TO: Madeleine Reinke, Kimley-Horn and Associates, Inc.
FROM: Cynthia Thye, Planner 1
DATE: March 19, 2026
SUBJECT: SP25-119: Lincoln Professional Park L2 - 7 Brews Coffee – Site Plan
Review Comments 03

Description: Lincoln Professional Park L2 - 7 Brews Coffee

LINCOLN PROFESSIONAL PARK FILING NO. 1
LOT 2, PARKER, CO
7 BREW - SITE PLAN
COVERSHEET

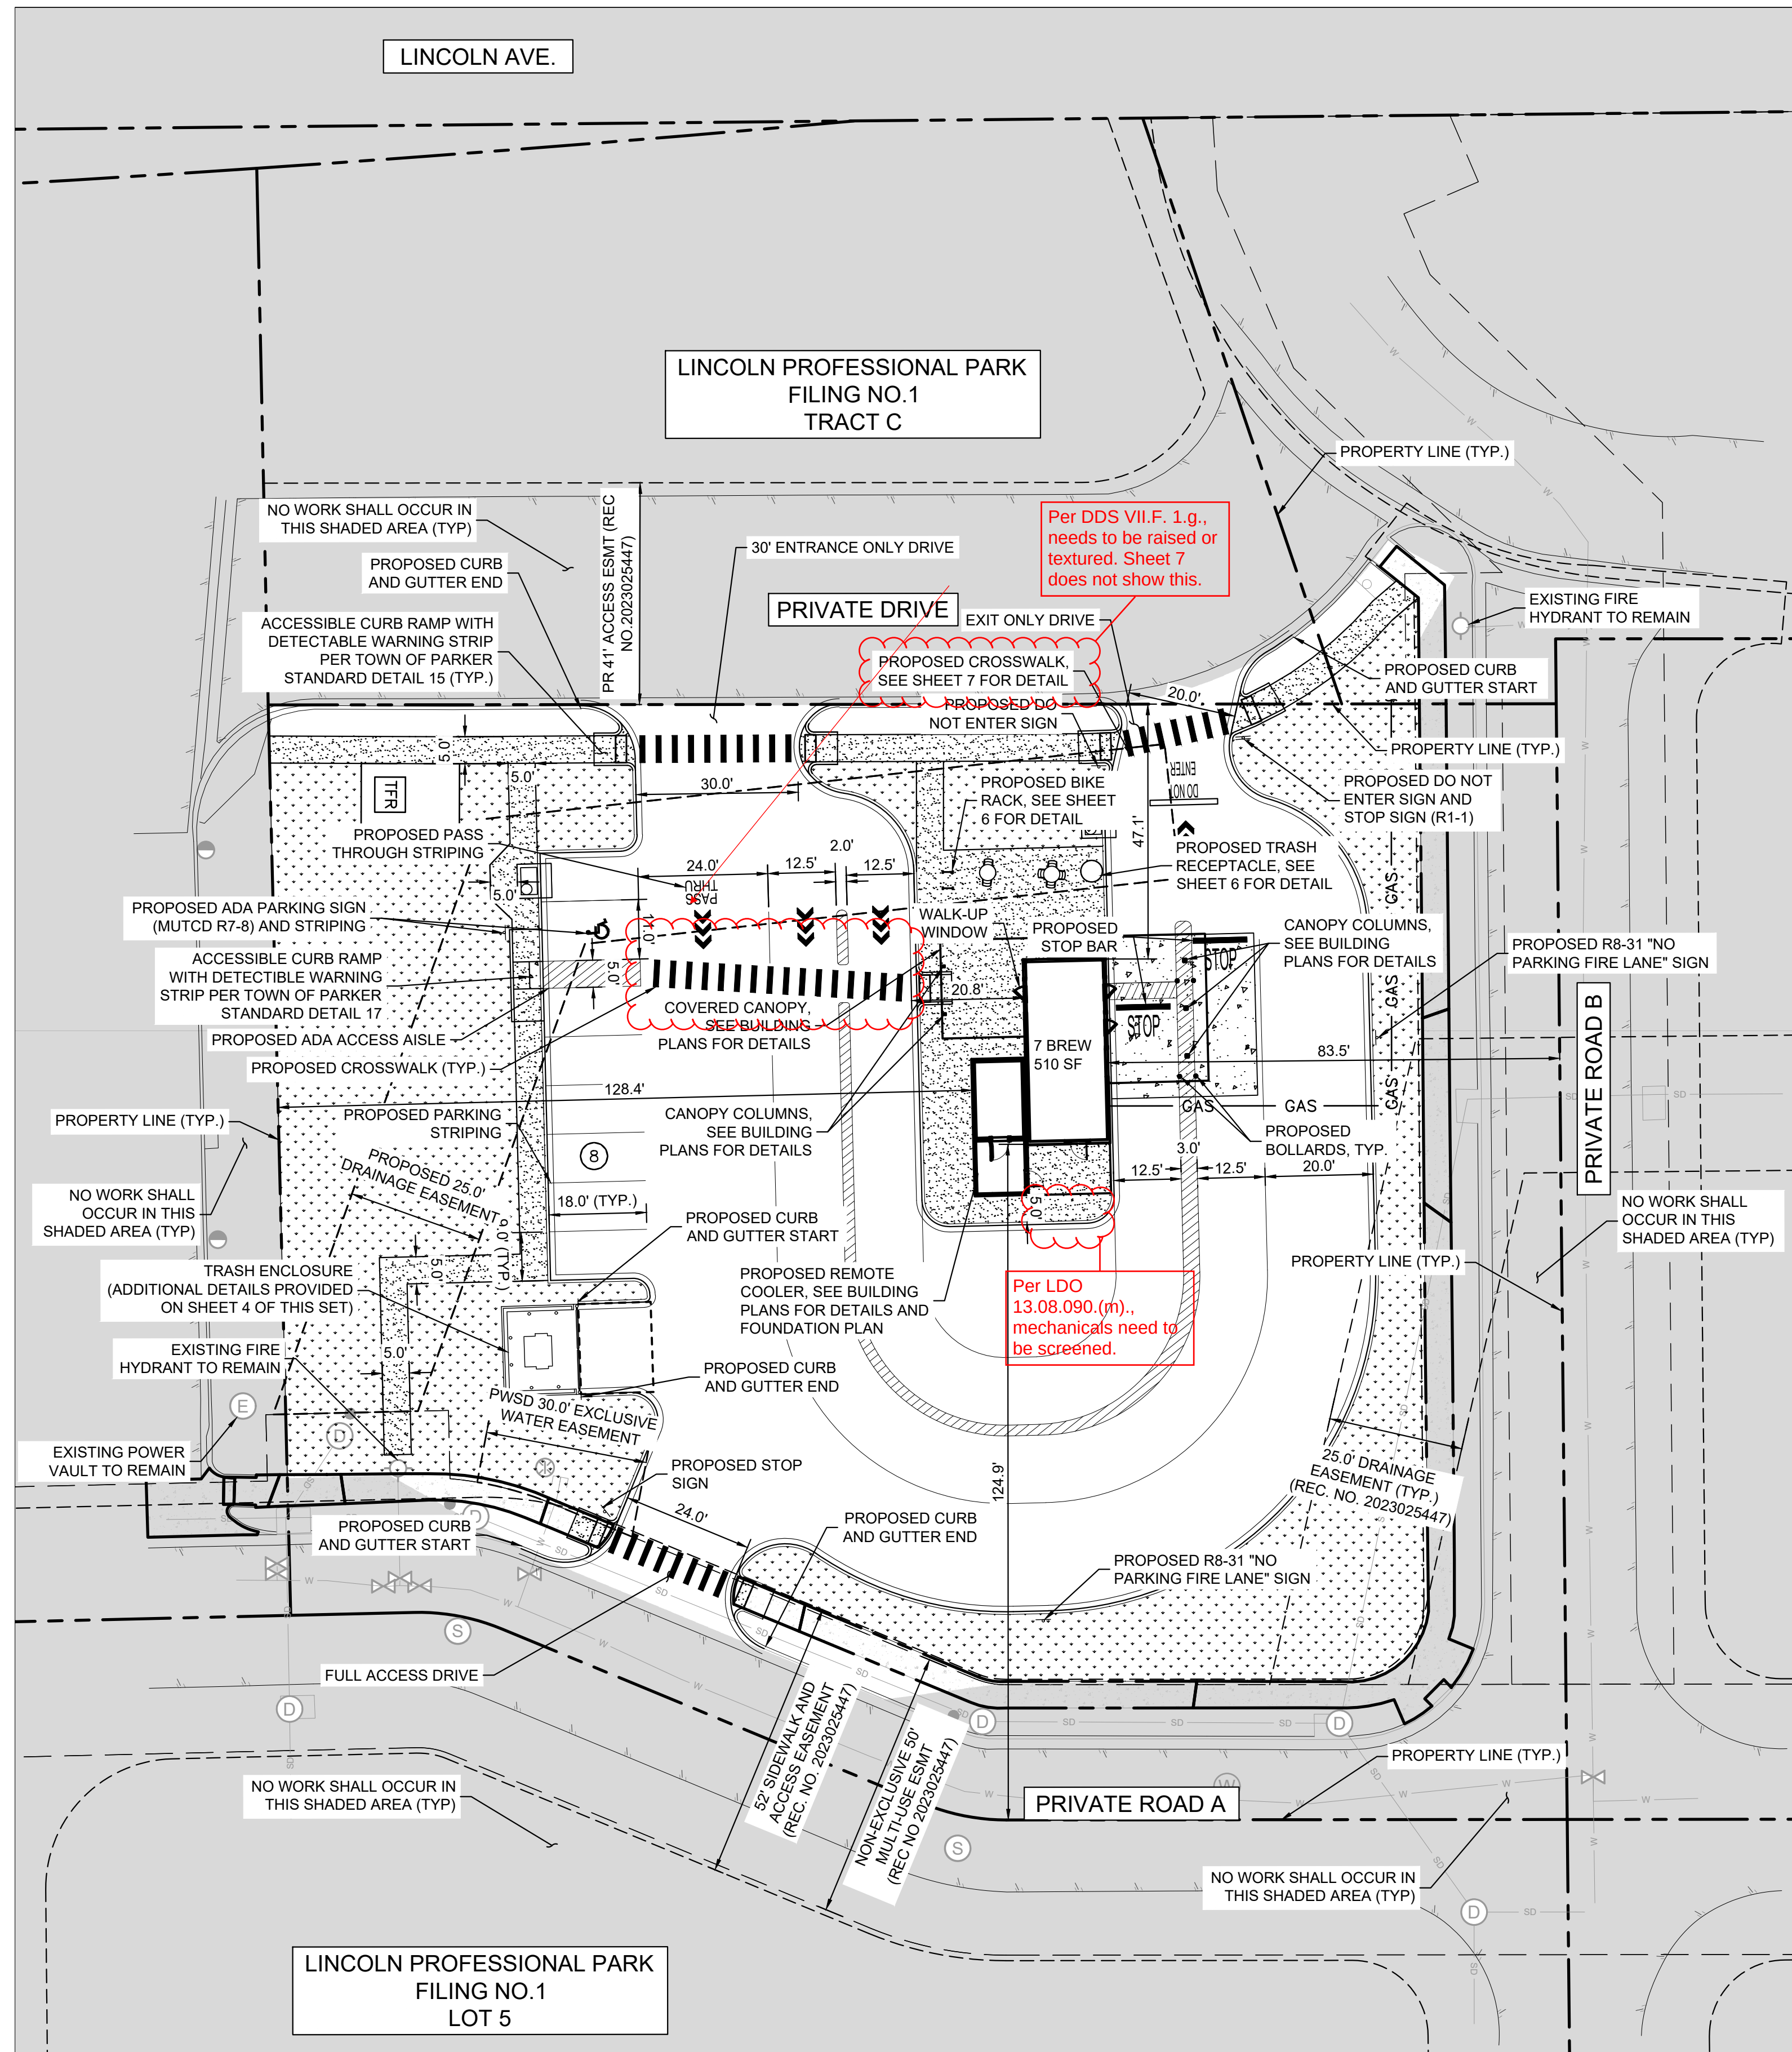
1. Correct errors on Land Use Summary Table on cover sheet.

1 EXTERIOR ELEVATION - SOUTH
3/8" = 1'-0"

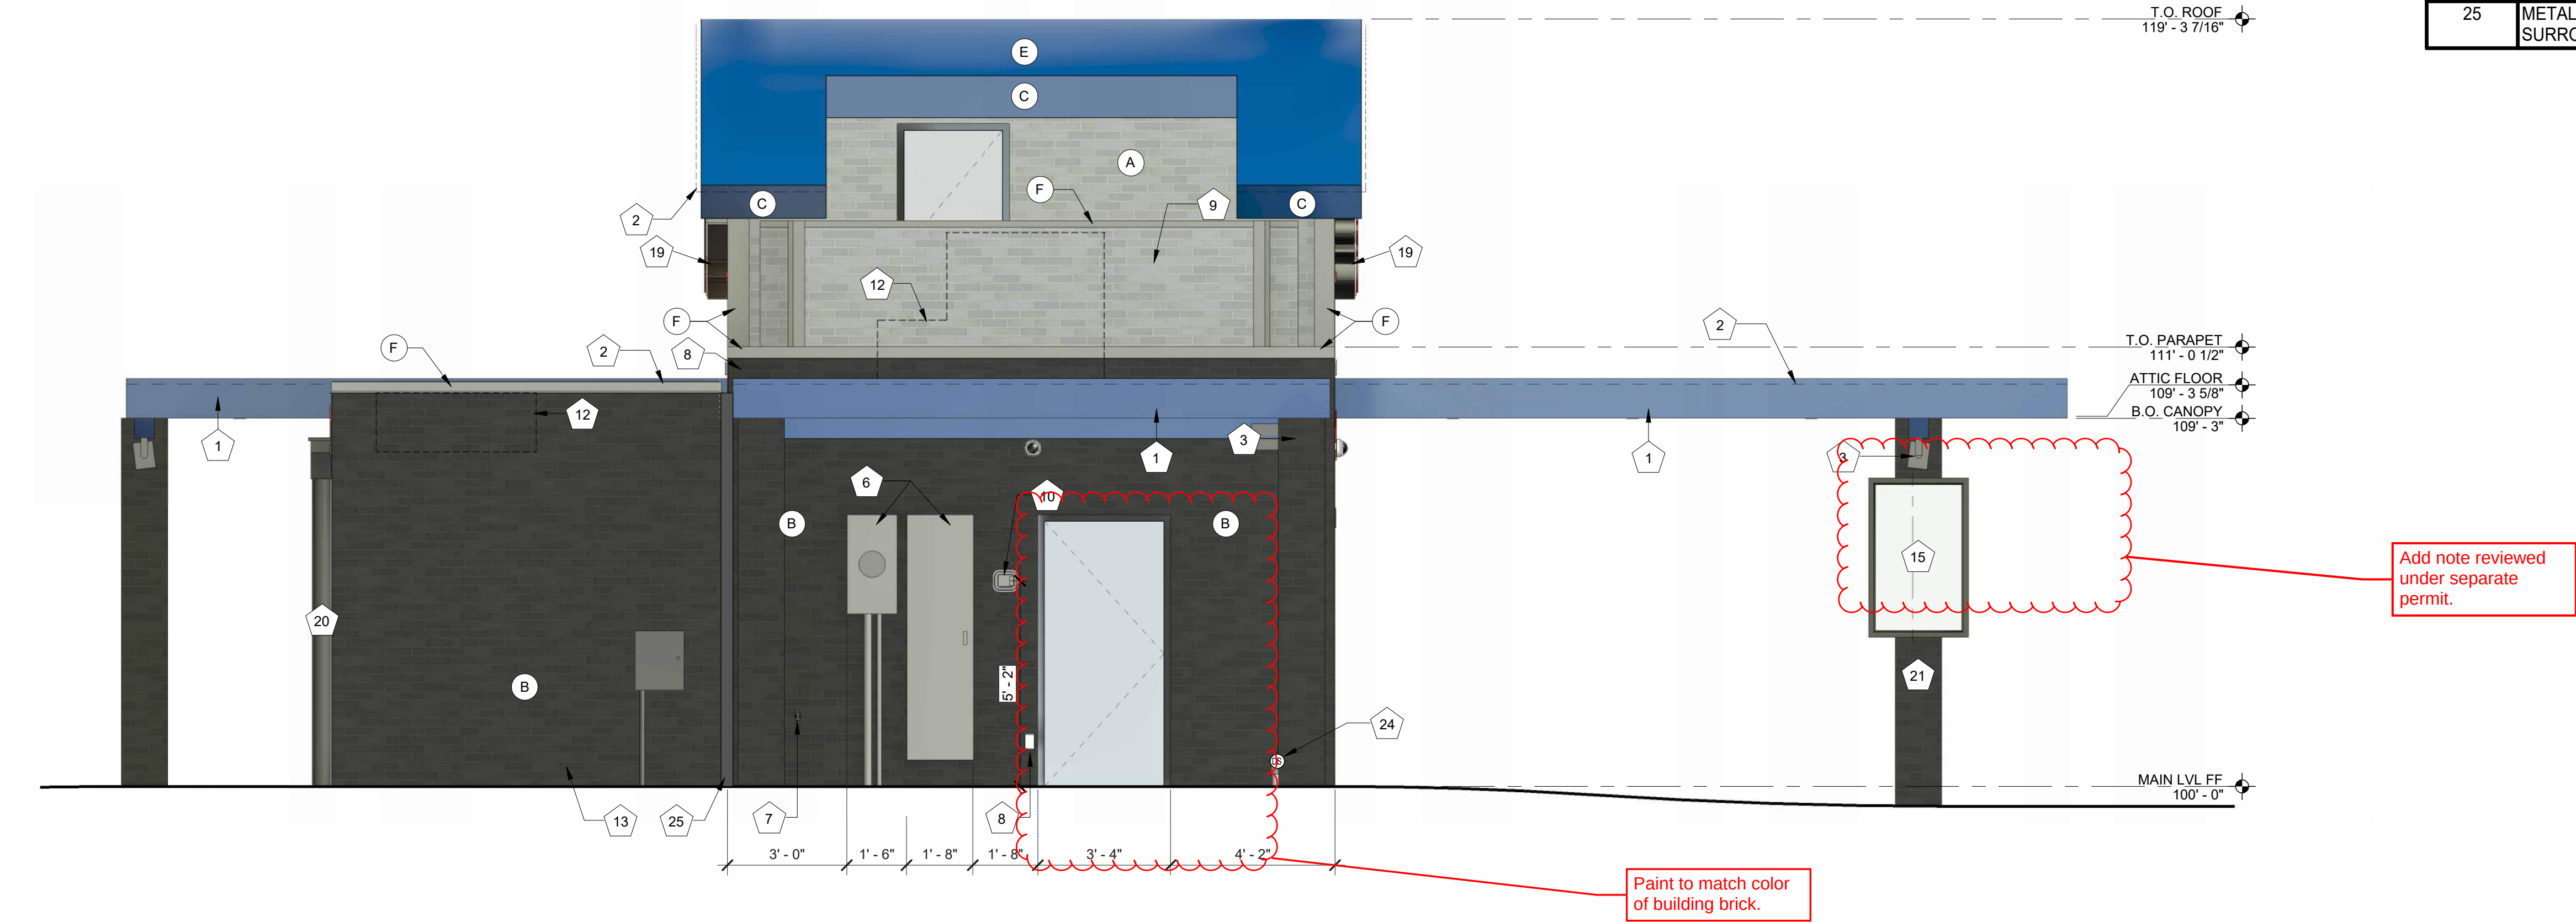
3. Applicants needs to screen mechanicals on south elevation per DLO 13.08.090.(m). If not evergreen, something else.

- 2. For south elevation paint door to match color of building brick and add note that sign on support is reviewed under a separate permit.**

1 EXTERIOR ELEVATION - EAST
3/8" = 1'-0"

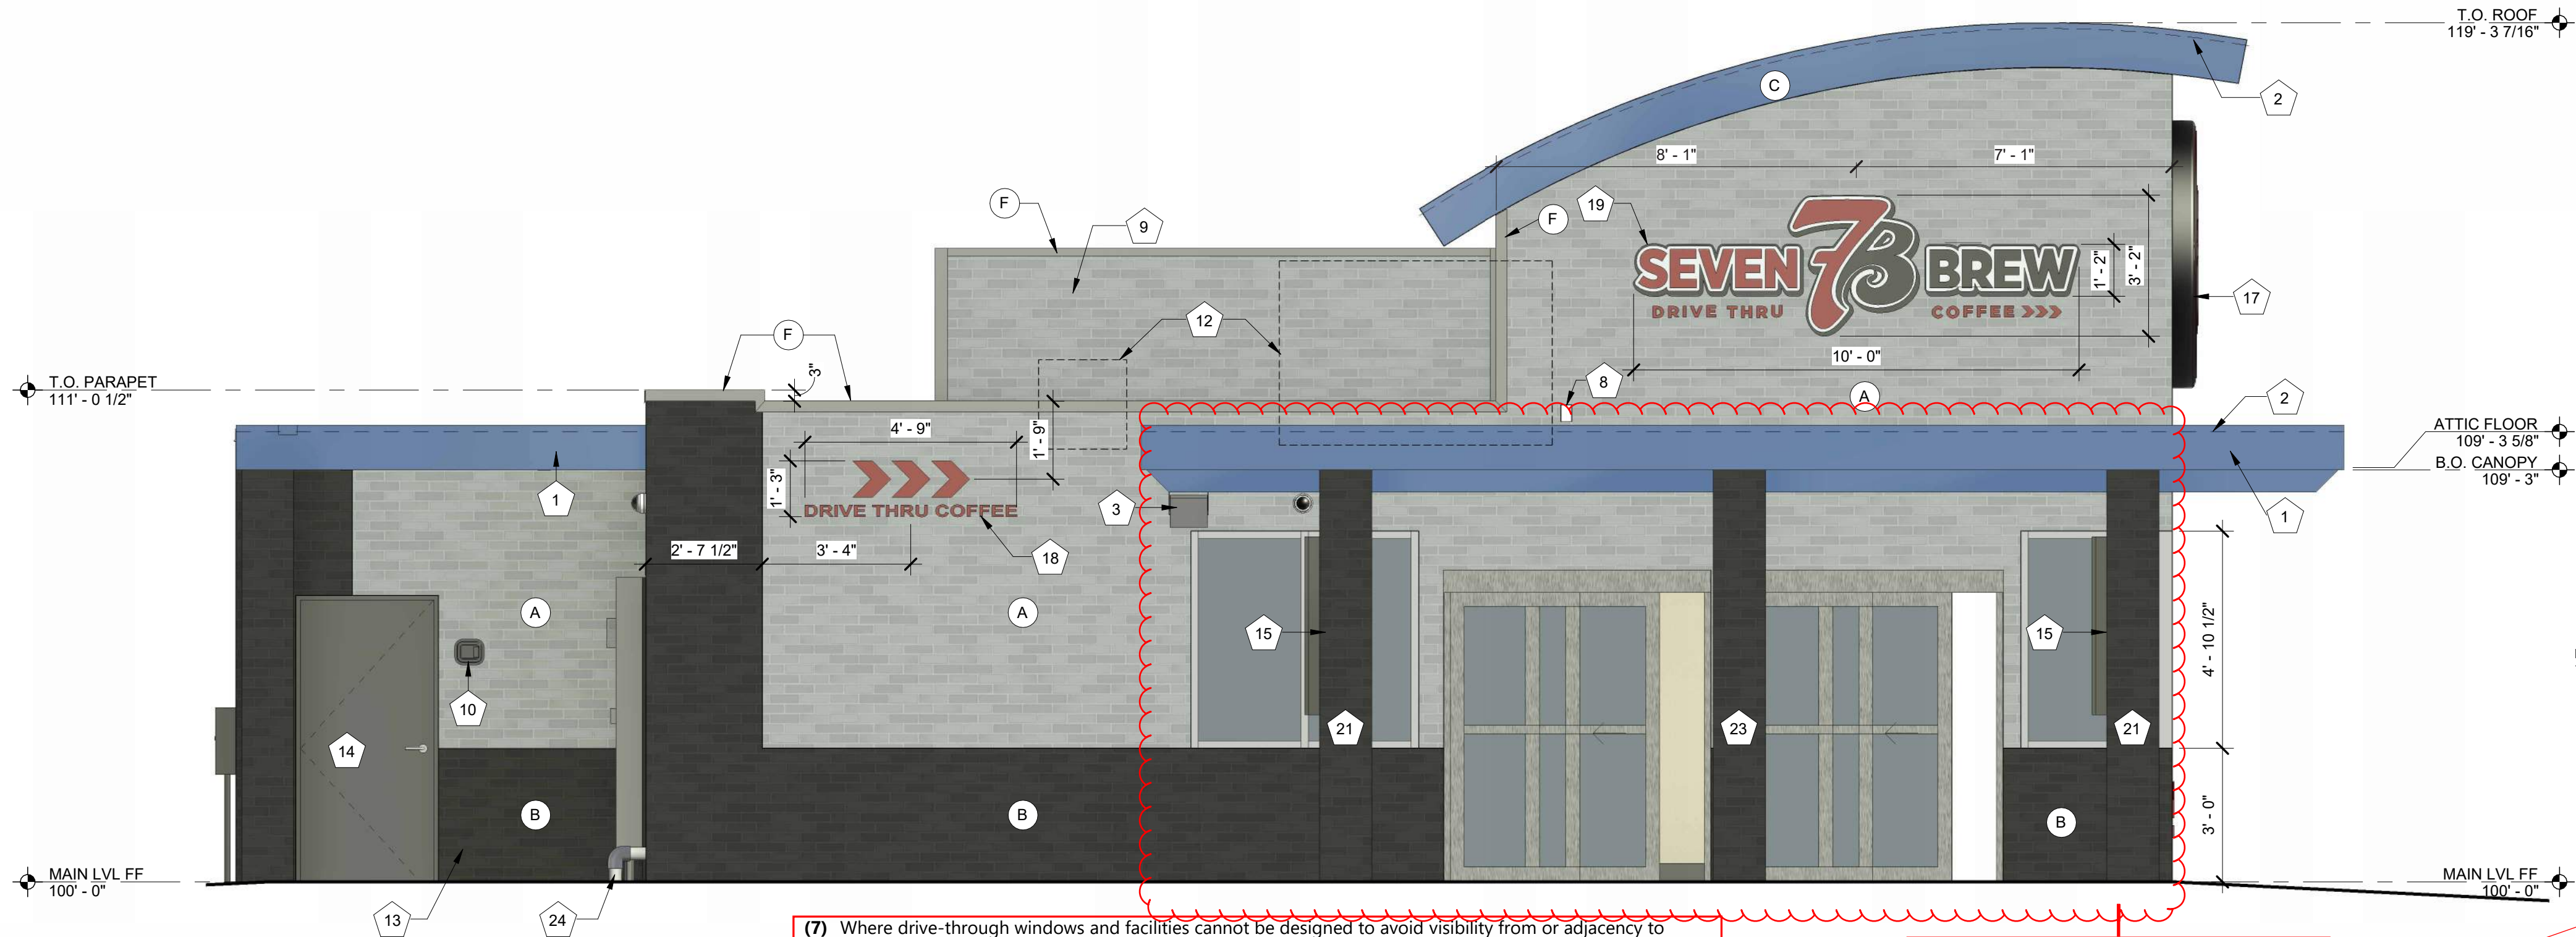
- 3. For east elevation need to screen drive-through per LDO 13.08.090.(k).7., this side of the drive-through faces a public roadway and needs screening. See Starbucks example on redlines.**
